**STAFF REPORT  
WEST ALLIS PLAN COMMISSION  
Wednesday, April 23rd, 2025  
6:00 PM**

- 5. Request for a six-month extension for conditional use permit to commence SoNa Lofts Phase 2, a proposed 5+ Unit Dwelling, at 6600 W. Mitchell St. (Tax Key No. 454-0656-000) by Daniel Katt d/b/a Mandel Group, Inc.**

**STAFF REPORT**  
**WEST ALLIS PLAN COMMISSION**  
**Wednesday, October 25, 2023**  
**6:00 PM**

- 2A. Conditional Use Permit for SoNa Lofts Phase 2, a proposed 5+ Unit Dwelling, at 6600 W. Mitchell St.**
- 2B. Site, Landscaping, and Architectural Design Review for SoNa Lofts Phase 2, a proposed 5+ Unit Dwelling, at 6600 W. Mitchell St. (Tax Key No. 454-0656-000)**

2 WEST ELEV.  
SCALE: 1/16" = 1'-0"

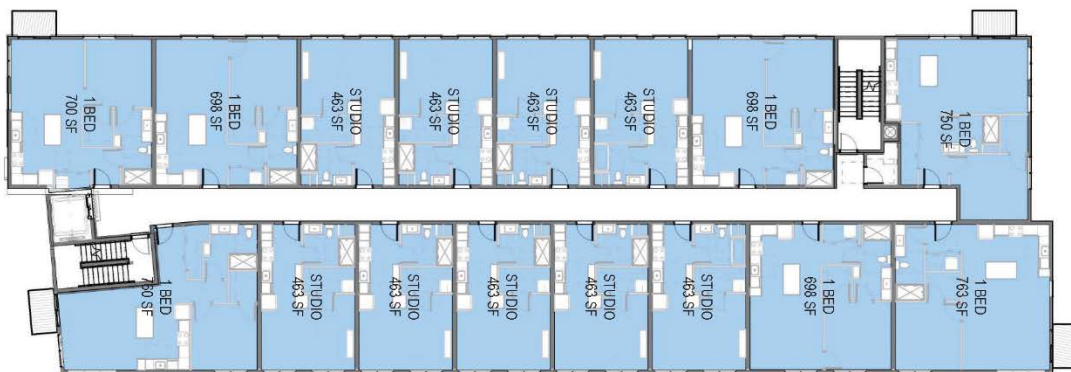
The west façade

includes a proposed mural on the exposed first-story. Lining the west façade's upper floors are a collection of windows for the apartment units. End units include balconies. The design of this façade is sleek and contemporary, while also intending to honor the historical legacy of industry. Staff is

recommending revisions to this façade that still honor the industrial legacy yet create additional visual interest. This may include vertical features to break up the façade, inseting/offsetting to create depth, ornamental overhangs, etc.

1. Revised Site, Landscaping, and Architectural plans submitted to show the following: a) at least 1 outdoor bicycle parking spaces and 10 indoor bicycle parking spaces to comply with Sec. 19.44 Vehicle Parking; b) show passageway from accessible parking stall to entrance door; c) additional design elements on the west façade for enhanced visual interest
2. A surety bond or other form of security as required under Sec. 12.13(14) of the Revised Municipal Code in the amount of 125% of landscaping and screening shall be executed by the applicant prior to the issuing of a building permit.
3. Common Council approval of the Conditional Use permit.
